# **ENVIRONMENTAL IMPACT STATEMENT**

## **TUCSON AQUEDUCT PHASE B**

TUCSON AQUEDUCT - PHASE B  
CENTRAL ARIZONA PROJECT

APPENDIX H  
RESPONSES TO COMMENTS

Figure 15

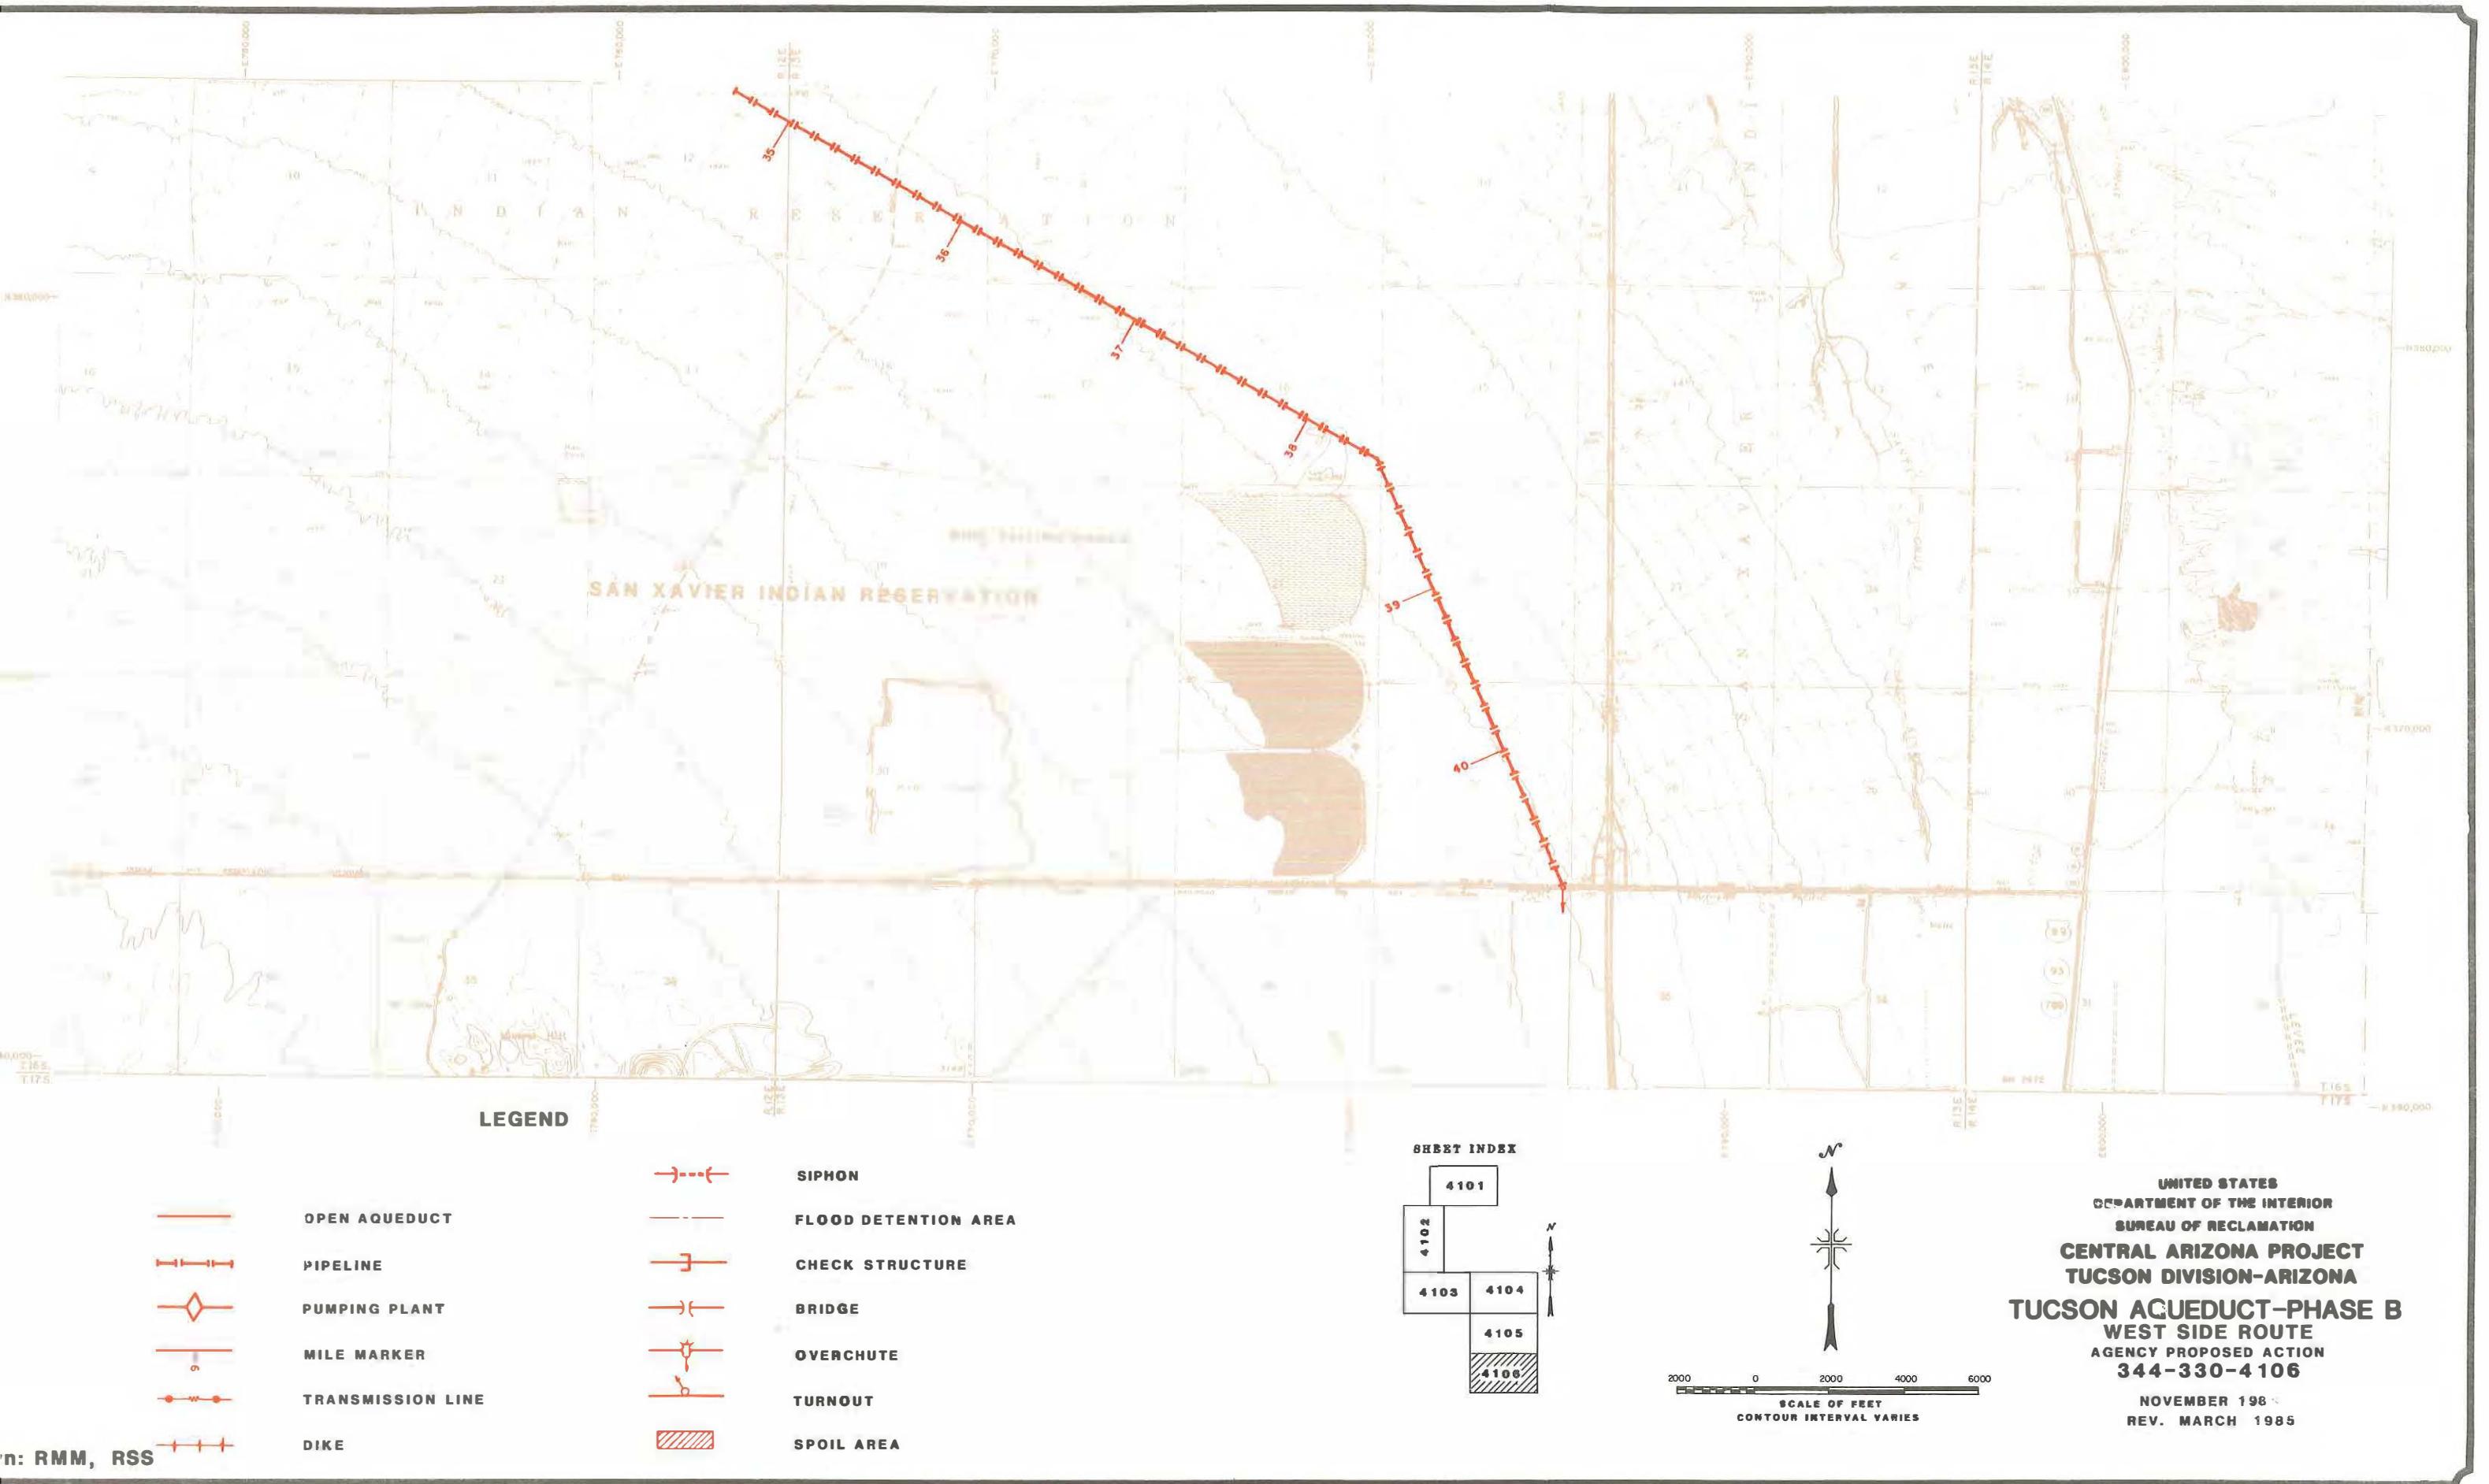
Figure 16: The proposed transmission line in the vicinity of Los Reales Road is not shown on the map.

Figure 53

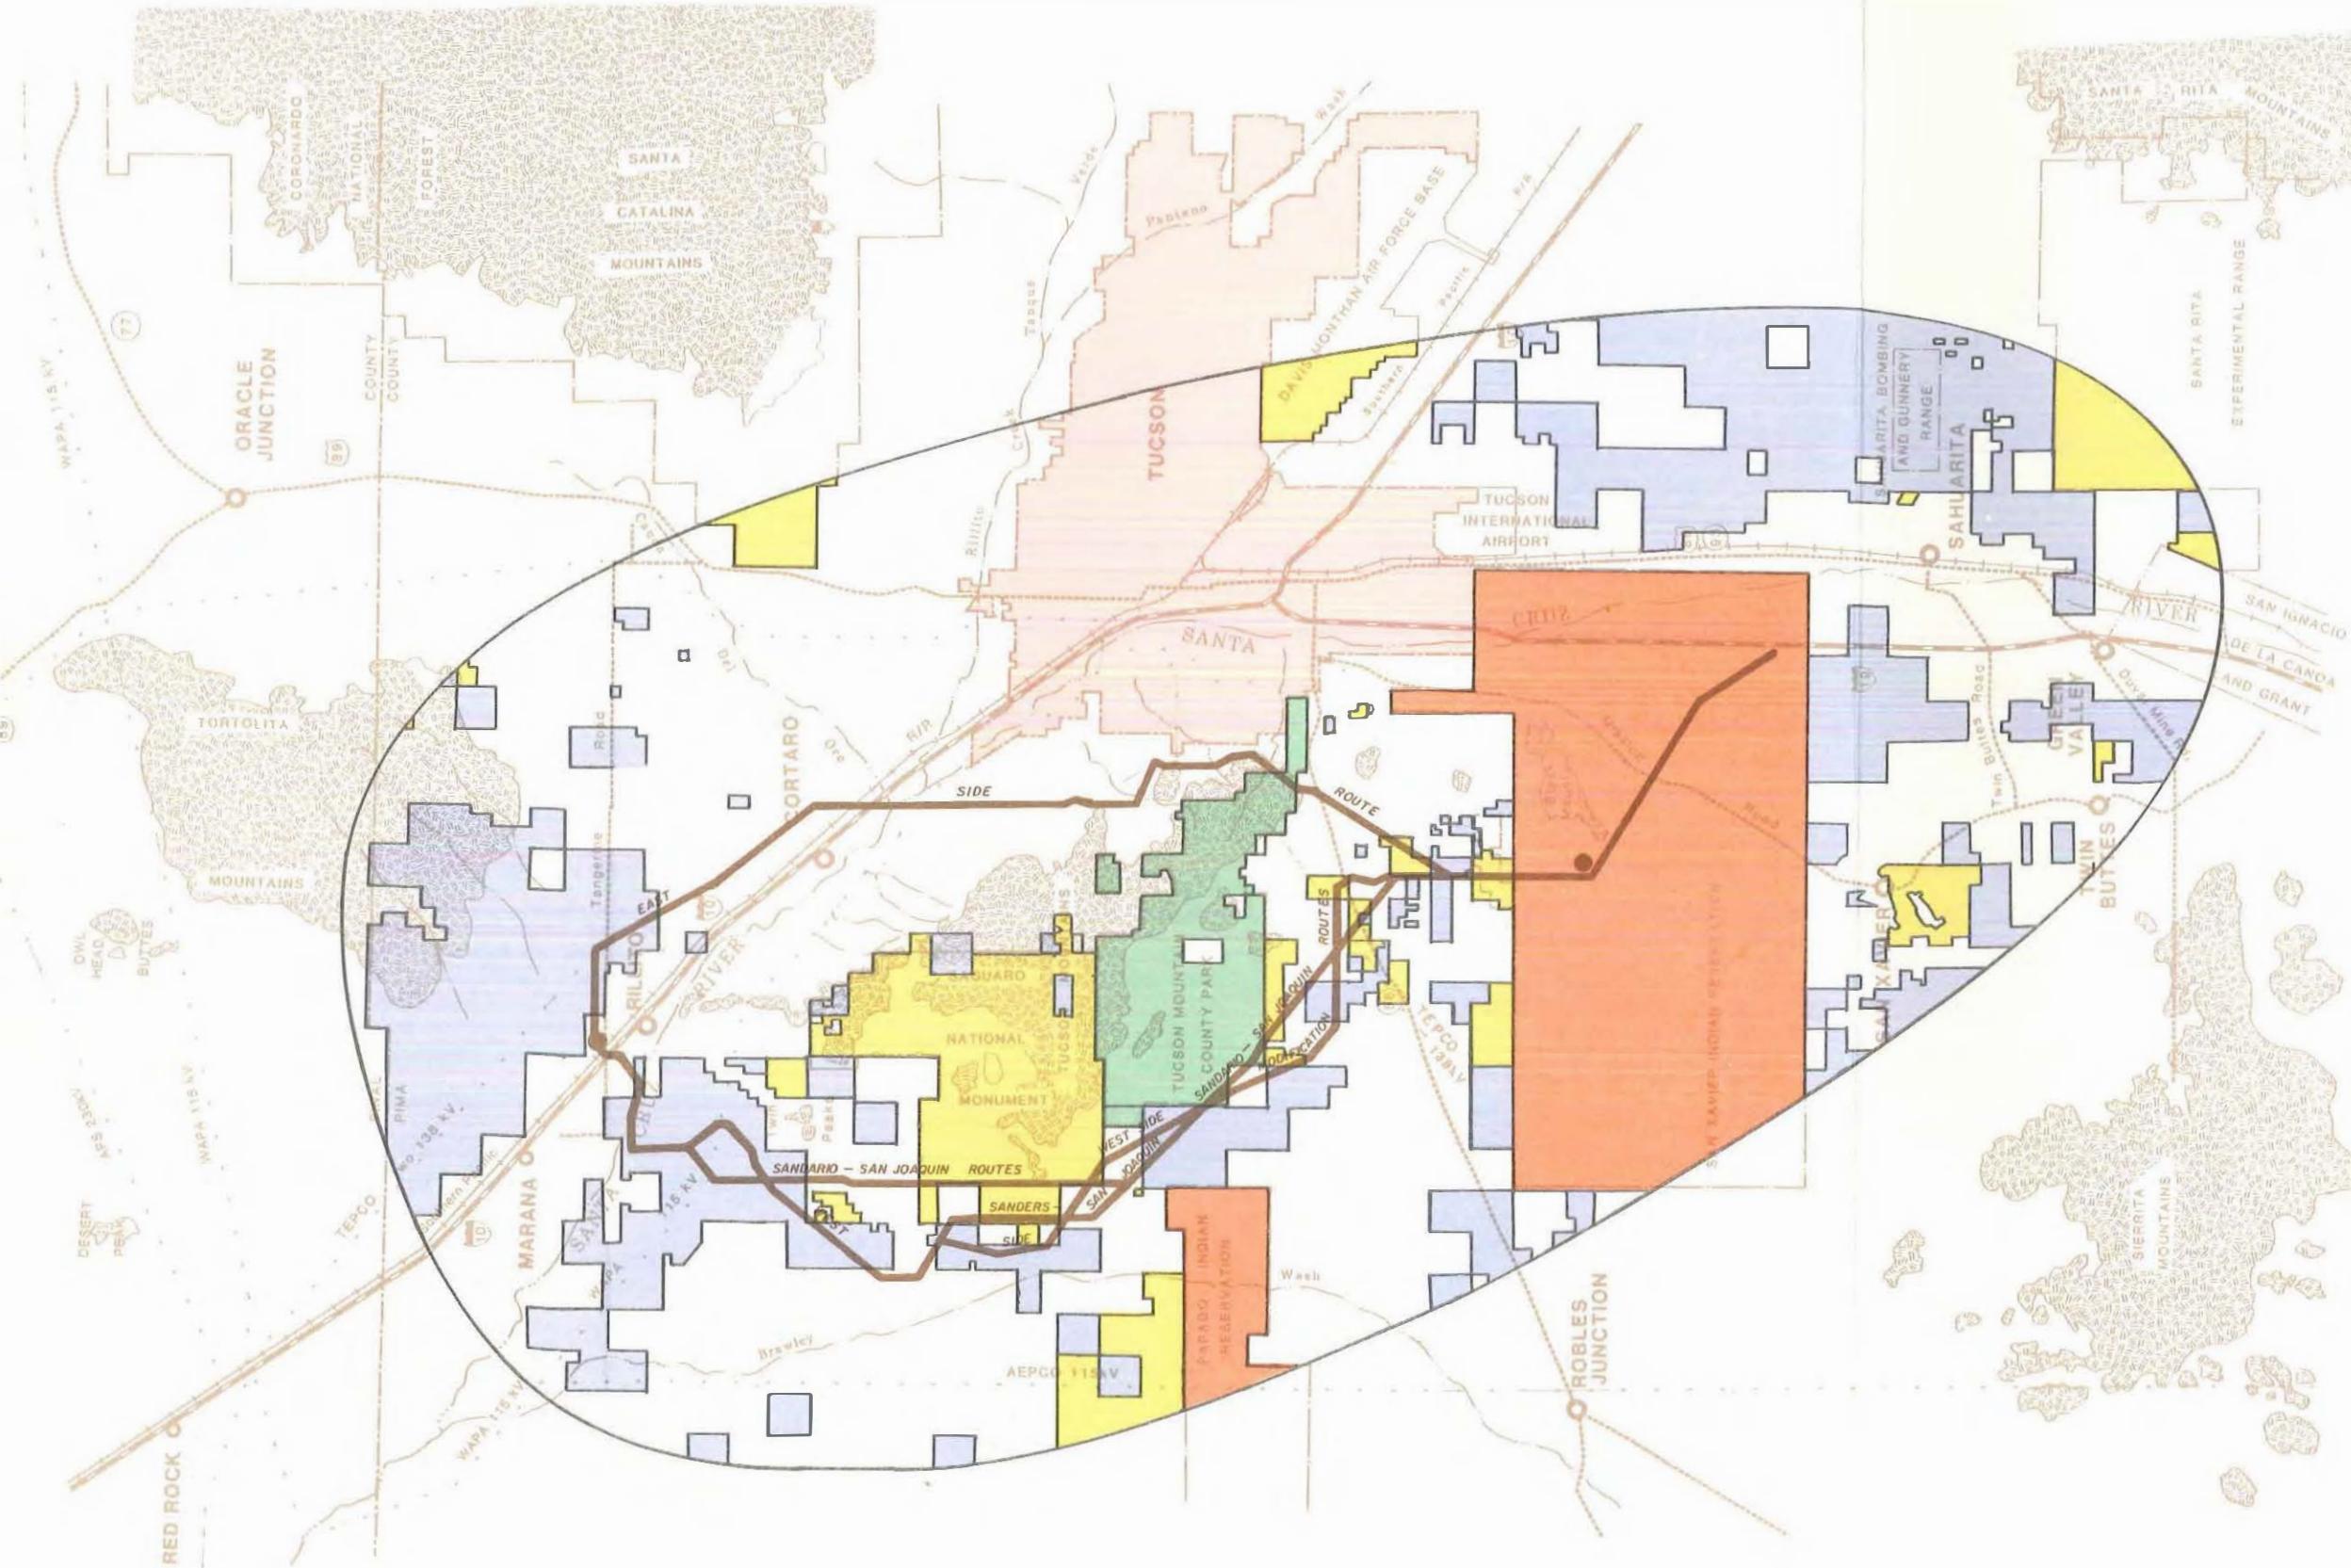
- 18-2 The lands status map (Figure 53) provides land ownership information.
- 18-3 The results of the recent inventory for Tumamoca globe-berry have been incorporated into the final EIS.
